# **Attachment D**

## **Comments**

**Attachment D-1: Agency Comments on the Alternatives Screening Methodology**

**Attachment D-3: Public Meeting Comments**

**Figure 1: Institutional Control Base Map**

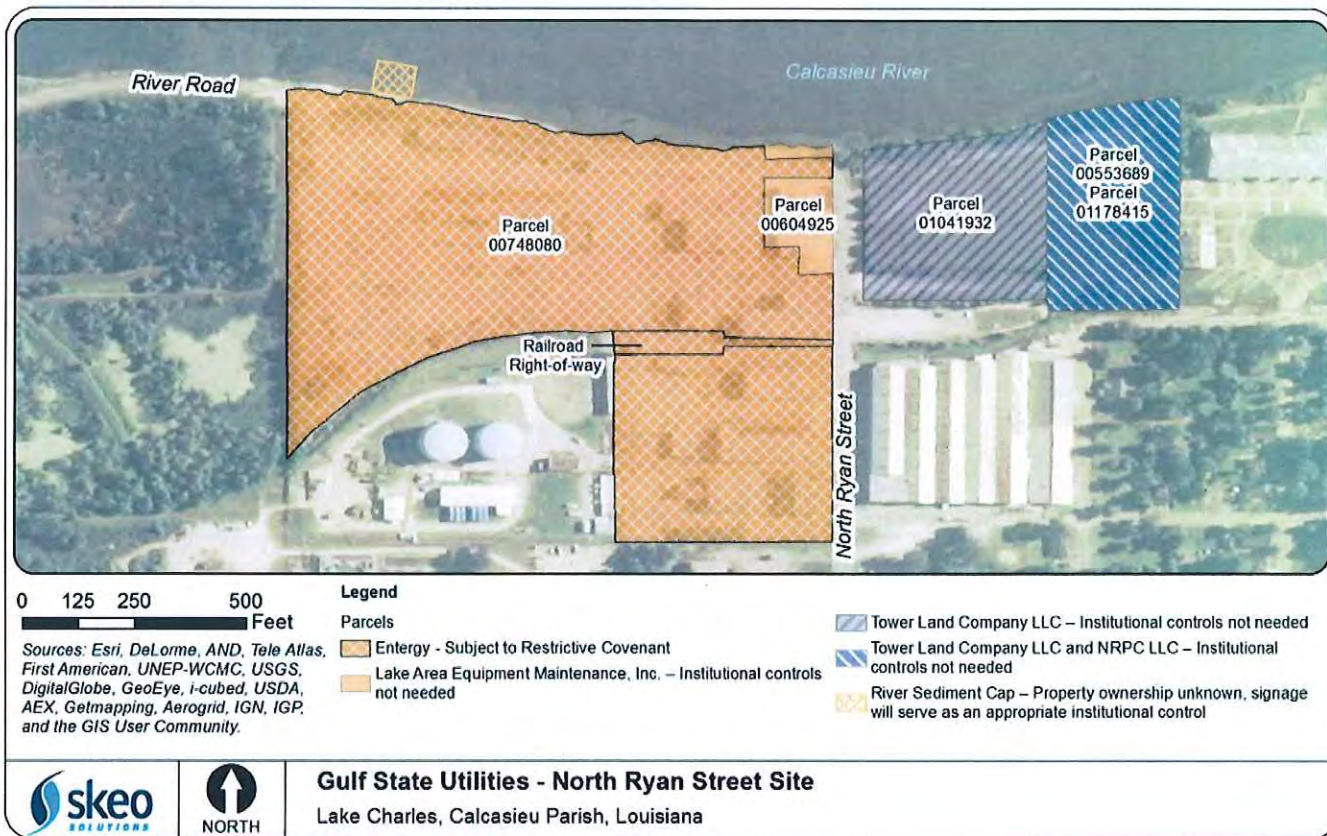
In light of the known contamination remaining in the subsurface soils near the proposed road construction areas depicted in the reasonable alternatives which involve the extension of Sulphur Ave. to Enterprise Blvd., the EPA believes that it is appropriate to provide comments for consideration that describe preliminary measures to prevent exposure to such contamination.

the former exposed tar area on the attached Figure 2 map) left low-level threat contamination in the subsoil. As a result, ongoing Site operations and maintenance are required to ensure that no unacceptable exposure risks posed by the Site occur in the future. Those ongoing Site operations and maintenance include but are not limited to Site maintenance, monitoring and compliance with the restrictions of the conveyance notice filed with the Entergy property deed that describes the land use restrictions necessary to control site worker and environmental exposure to low-level threat contamination remaining onsite. These restrictions prohibit any unauthorized excavations or use of contaminated soil and limit the future use of the property to commercial or industrial purposes. The attached Figure 1 from EPA's 2015 Five Year Review for the Site shows the extent of the conveyance notice.

- Prior to the start of any construction or excavation activities, EPA must review and approve a Soil and Stormwater Management Plan that will prevent exposure to contamination remaining in the subsurface soil. The plan should include but not be limited to, sampling and analysis plan of subsurface soils for PCBs, VOCs, and PAHs; dealing with and disposal of contaminated soil encountered during excavation; ensuring that disposal of the contaminated soil is in accordance with State and Federal law; and stormwater measures utilized to minimize stormwater contact with contaminated soil.
